ADDENDUM 3 – JOB 40

TO: All prospective bidders on project IM-8-029(132)078, Job No. 40 scheduled for the November 14, 2014 bid opening.

November 6, 2014

Type of Work: PCC RECONSTRUCTION, RAMP HBP MILL & OVERLAY, BRIDGE PIER PROTECTION, DRAIN BOX CULVERTS, CENTERLINE PIPES, GUARDRAIL, FENCING & INCID

STATE	PROJECT NO.	SECTION NO.	SHEET NO.
ND	IM-8-029(132)078	10	1

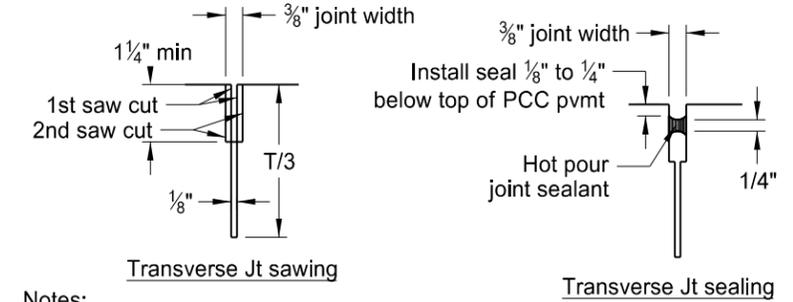
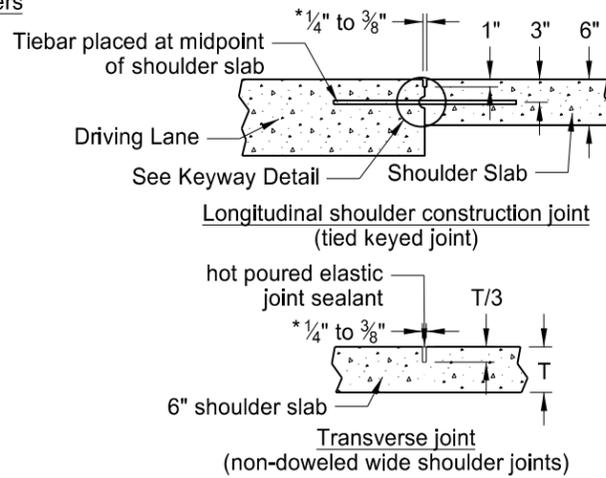
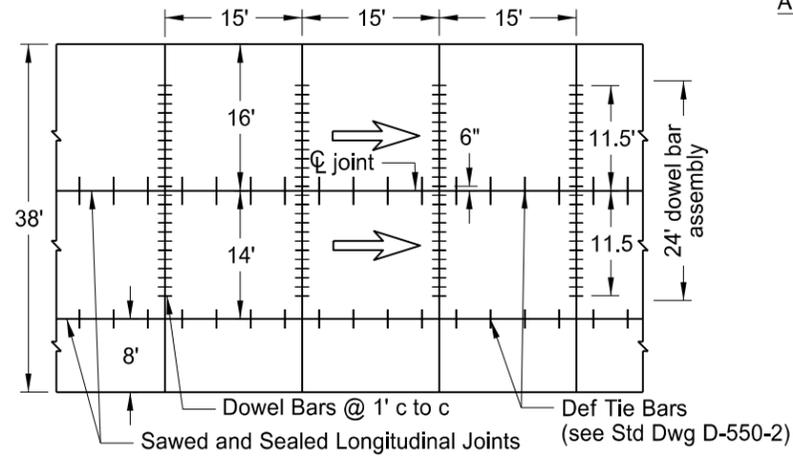
- Pavement Marking items revised to painted

PCC Joint Details

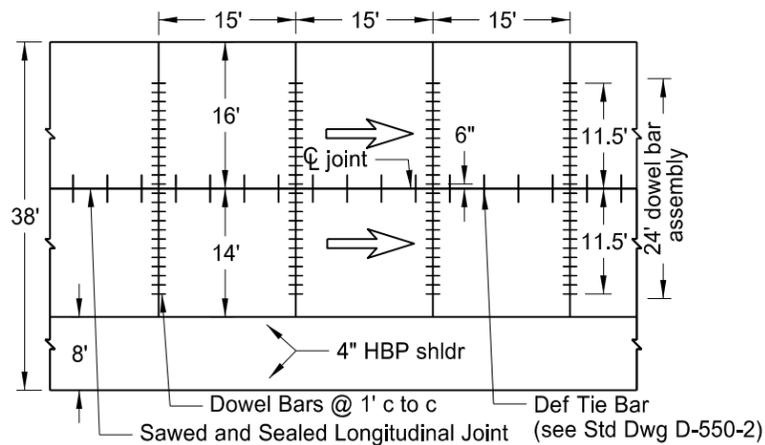
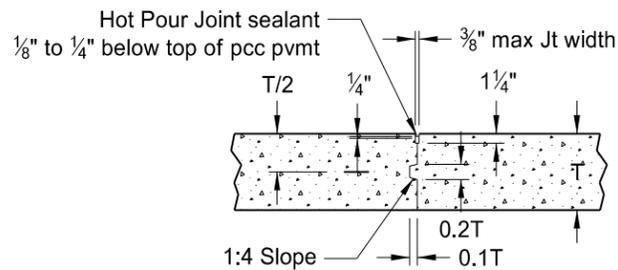
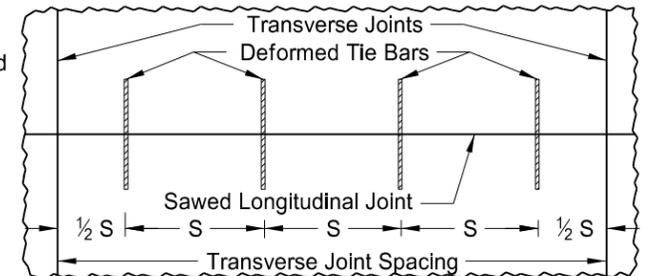
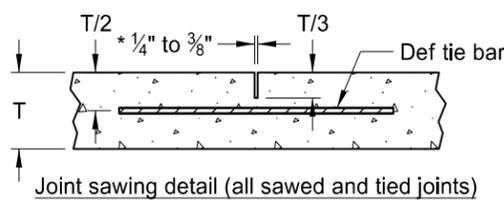
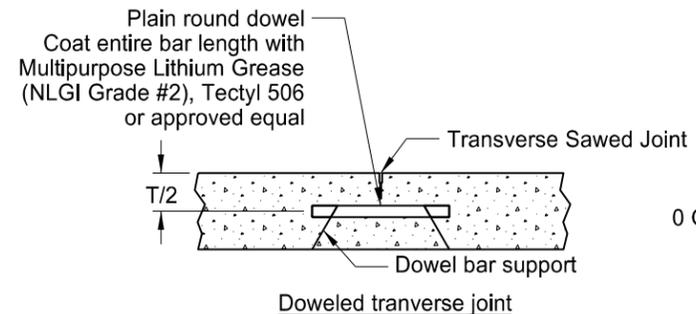
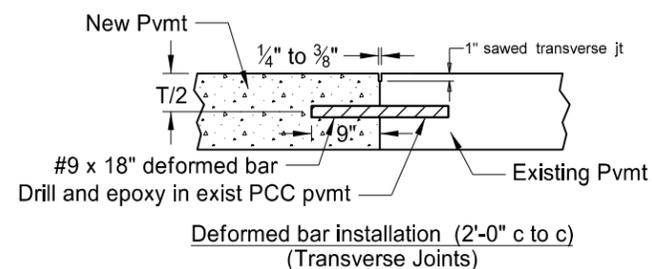
- Added Concrete Ramp dowel bar detail
- Revise Grade 60 longitudinal bar spacing to 45”

Proposed Typical Section
Argusville to Hunter
Alternate A - Concrete Shoulders
Interstate 29 - Argusville to Hunter NB

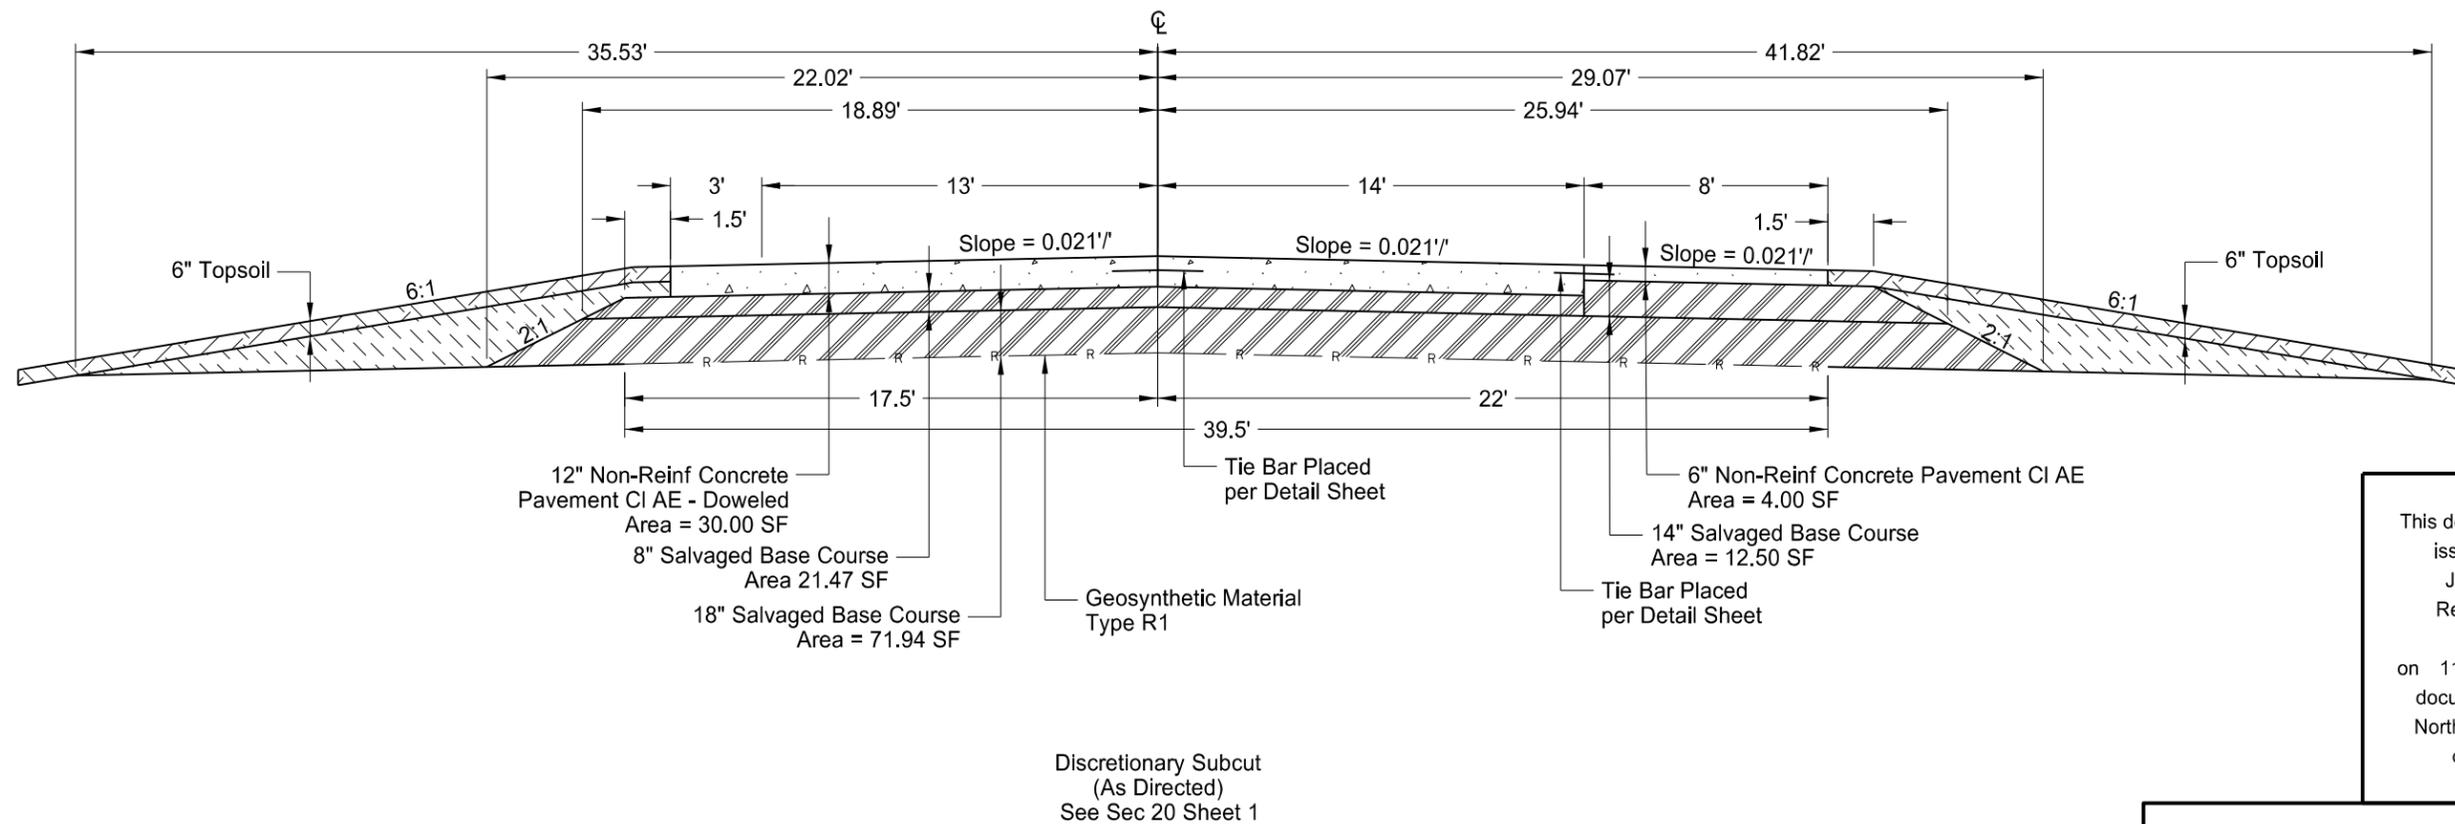
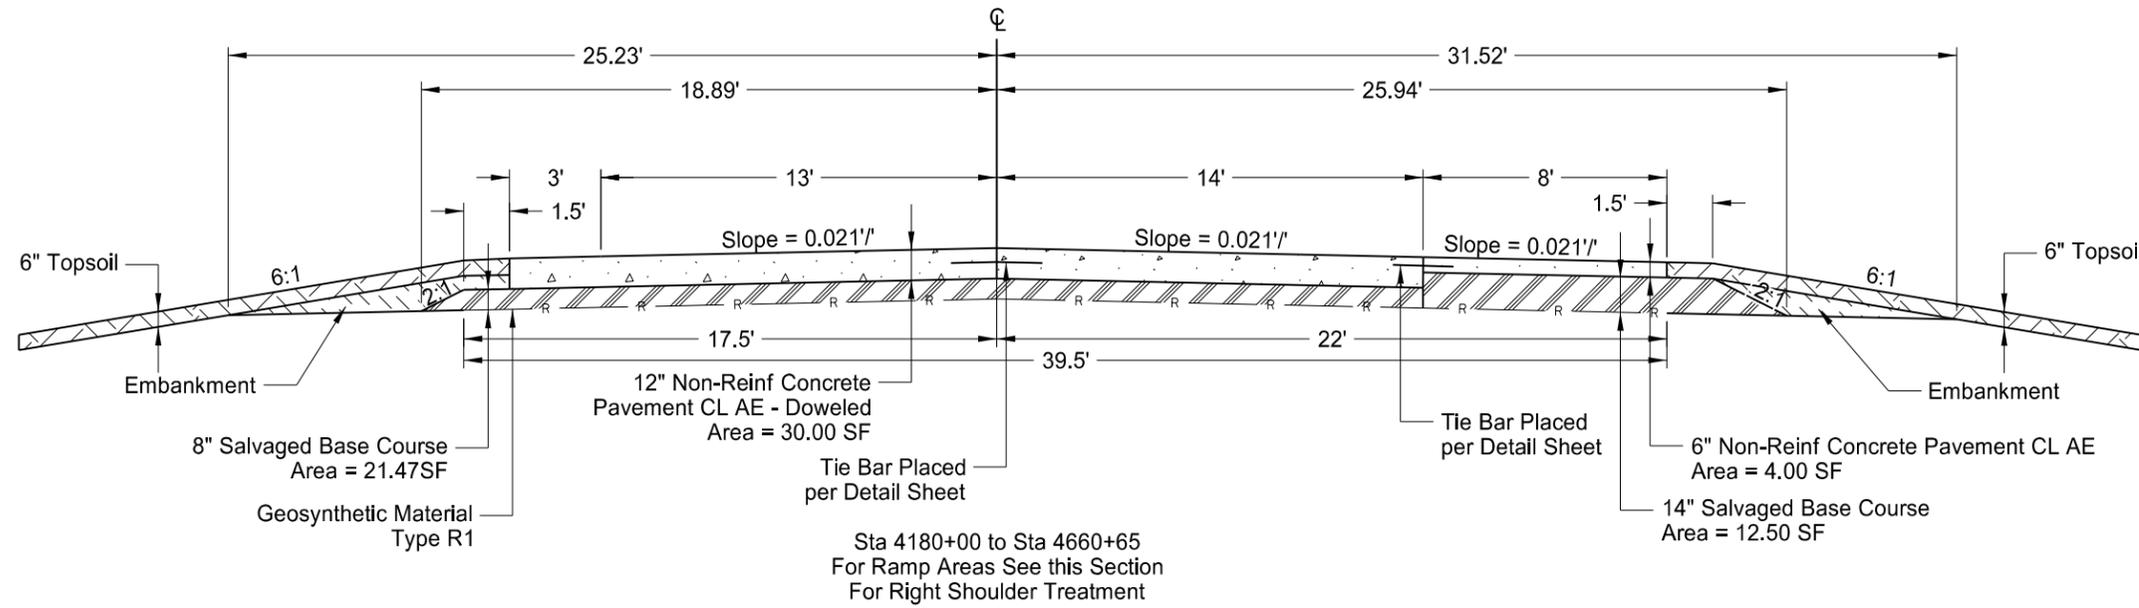
- Revised fabric width from 23.5’ to 22’ right of centerline

Proposed Typical Section
 Argusville to Hunter
 Alternate B - Concrete Median Shoulder
 Interstate 29 - Argusville to Hunter NB

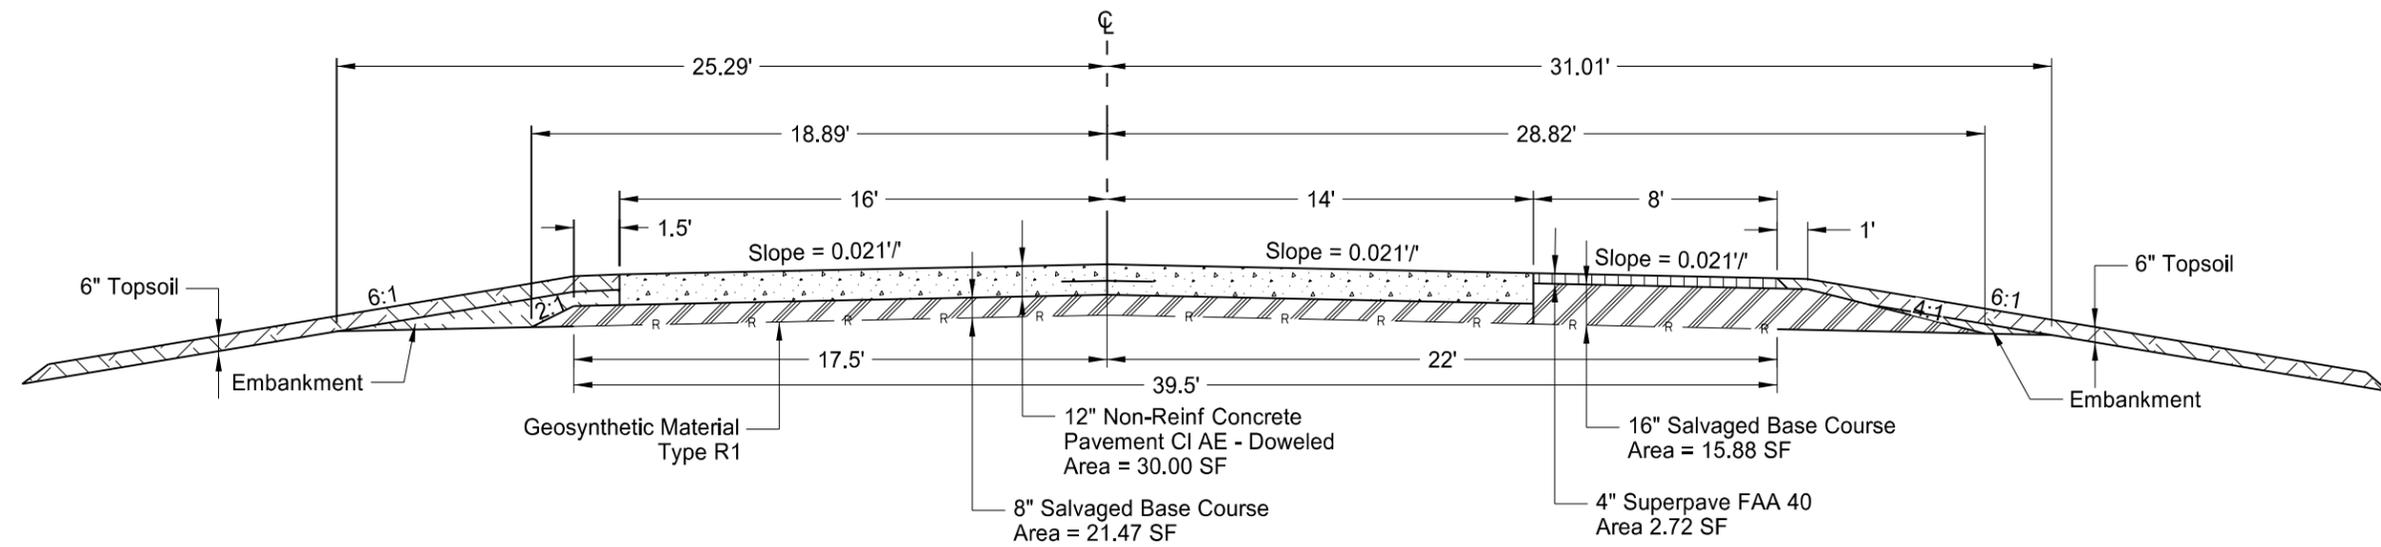
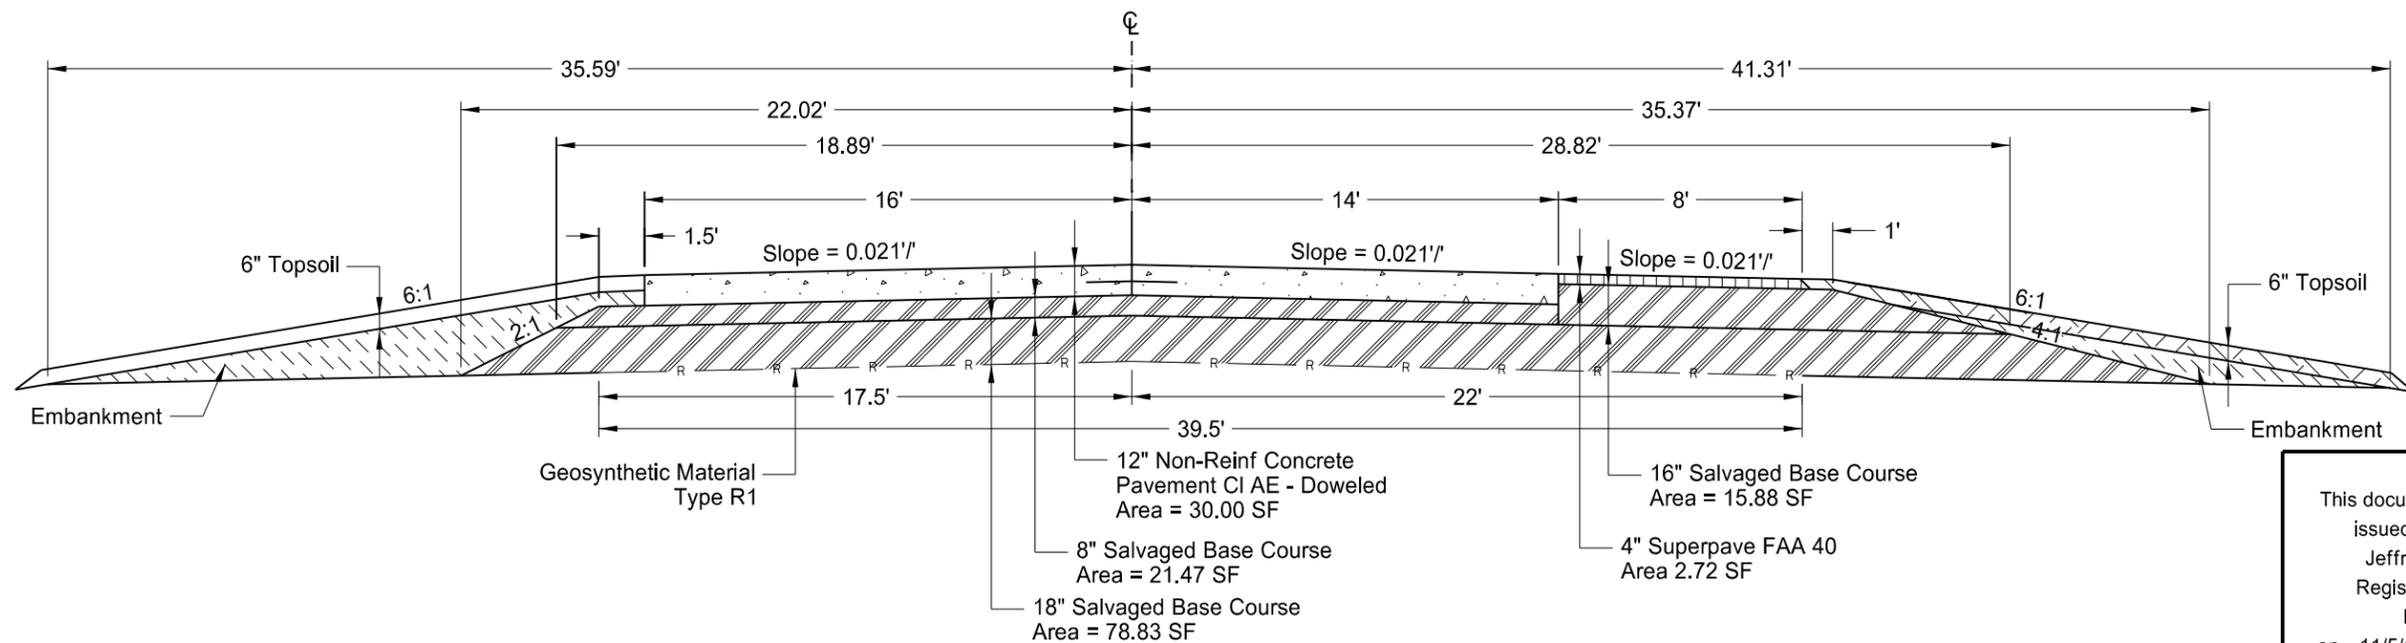
- Revised fabric width from 23.5’ to 22’ right of centerline

W-Beam Guardrail Layout
Outside Pier Protection

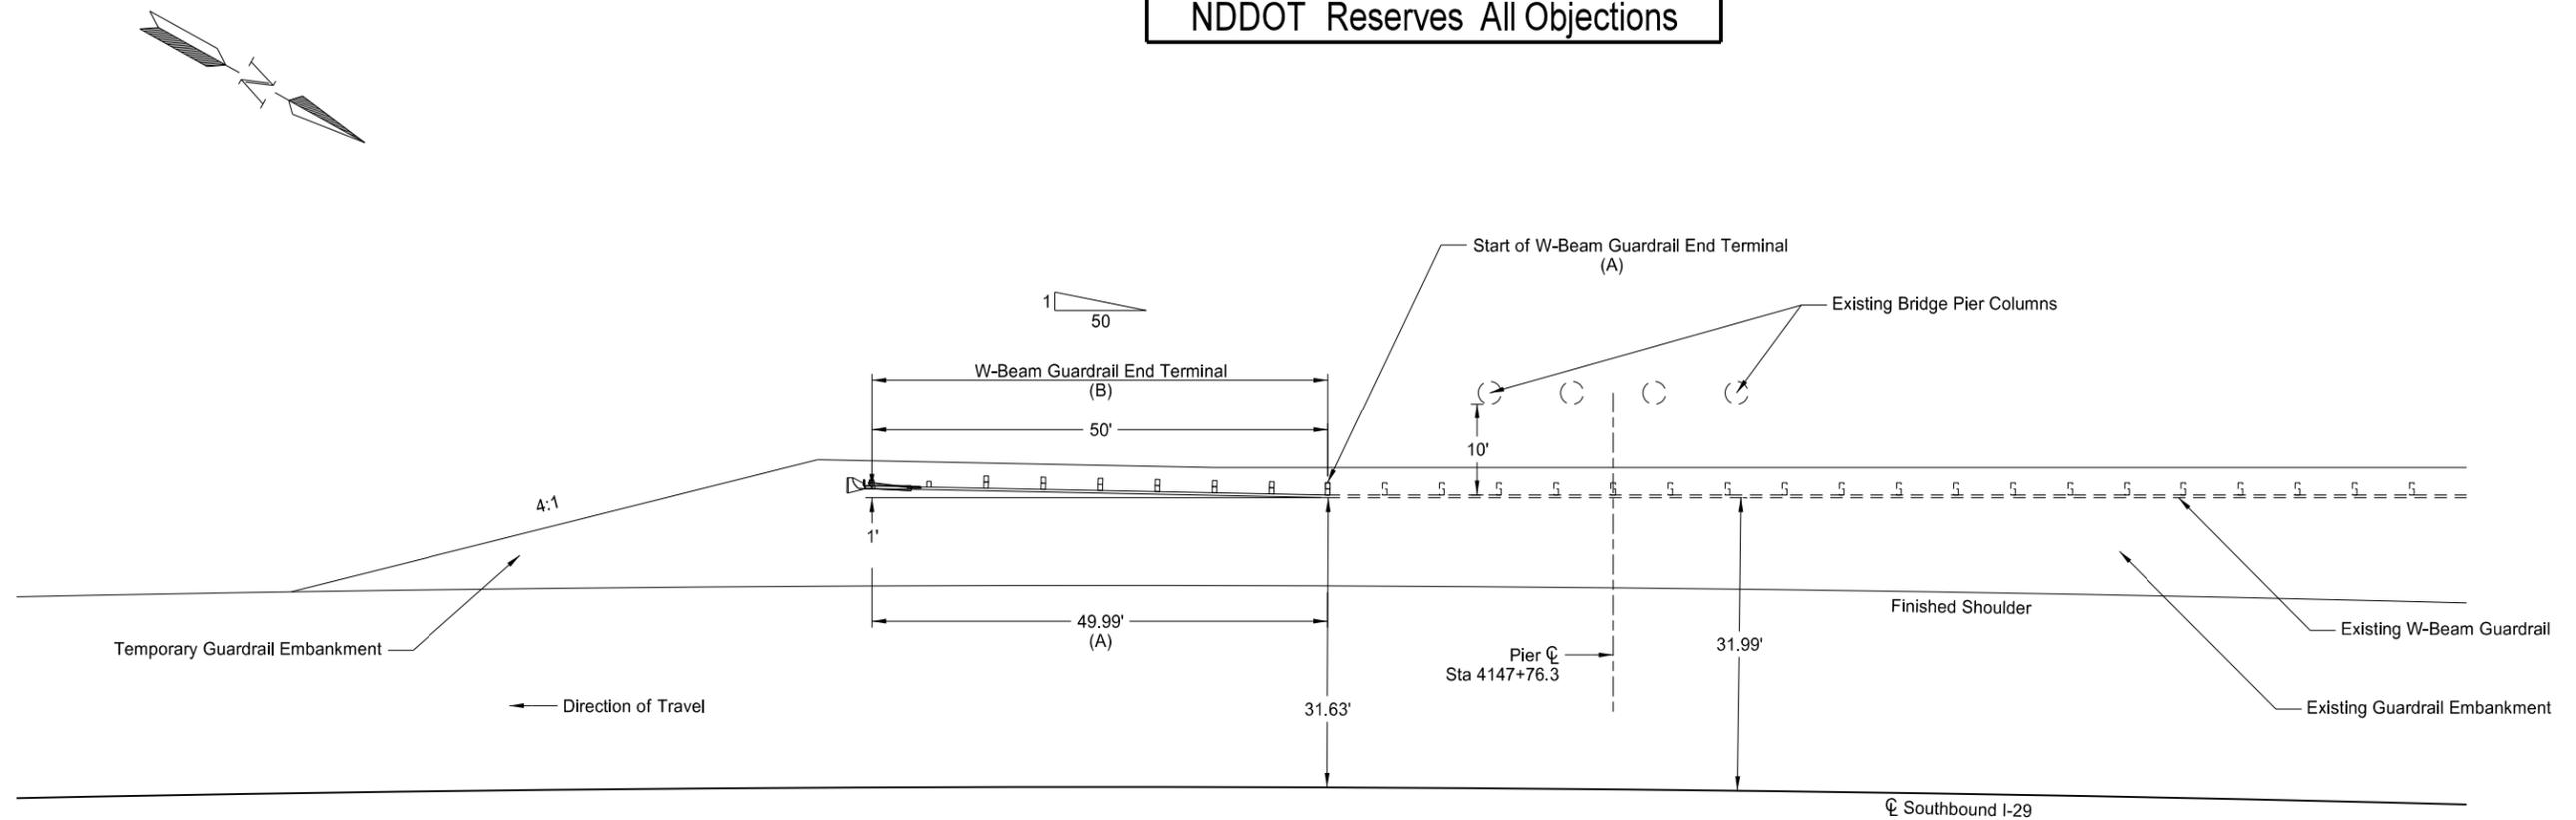
- Note (B) Revised to eliminate ET-2000 end terminal
